RIDGEWOOD SUBDIVISION, **RESUBDIVISION OF LOT 1**

APPLICATION NUMBER 33 DATE January 8, 2004
APPLICANT Ridgewood Subdivision, Resubdivision of Lot 1
REQUEST Subdivision

SITE PLAN

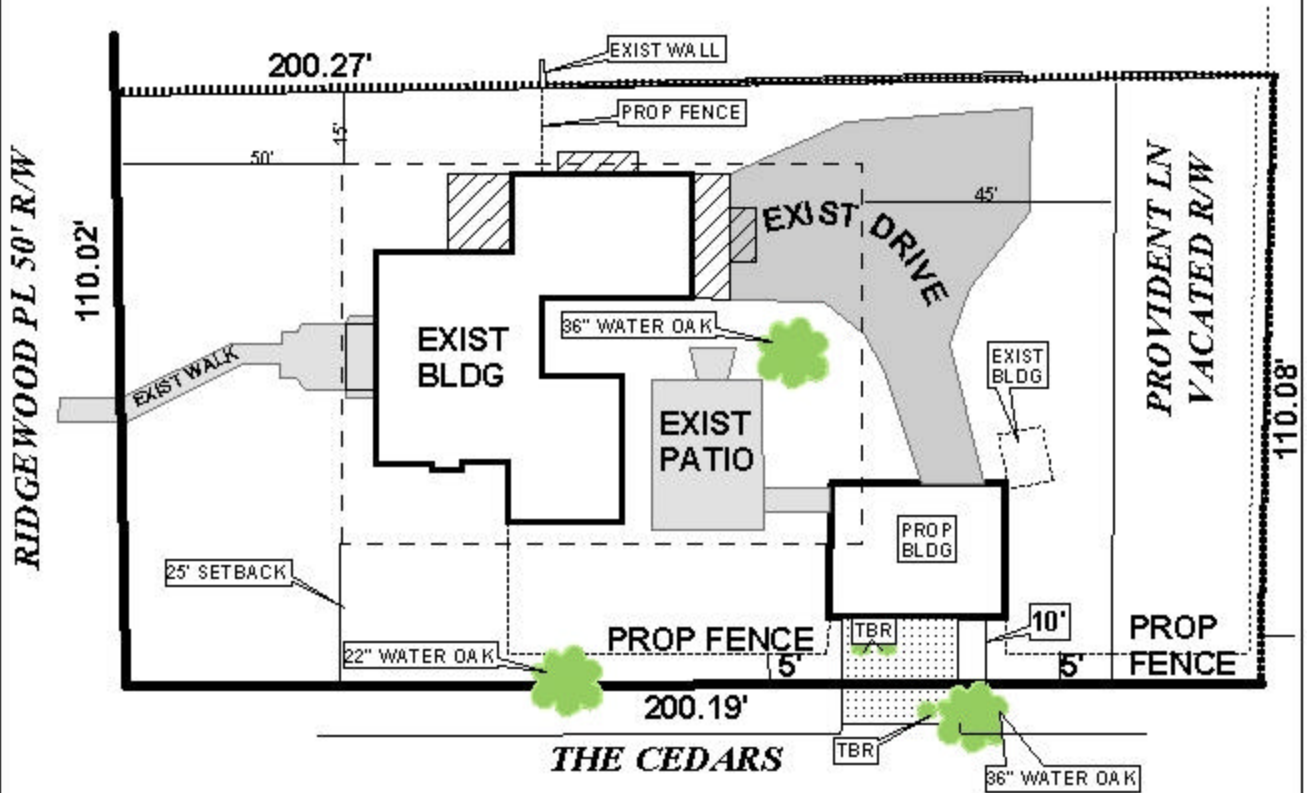
As illustrated on the Detail Map, the applicant proposes to construct a 26' x 33' garage within 10' from the South (street) side property; therefore, the applicant must have the placement of the proposed garage approved by the Board of Adjustment prior to permitting of the structure.

The plat meets the minimum requirements of the Subdivision Regulations and is recommended for Tentative Approval subject to the following condition: 1) the placement of a note on the final plat stating the approval from the Board of Adjustment for the placement of the garage prior to the issuance of any permits.
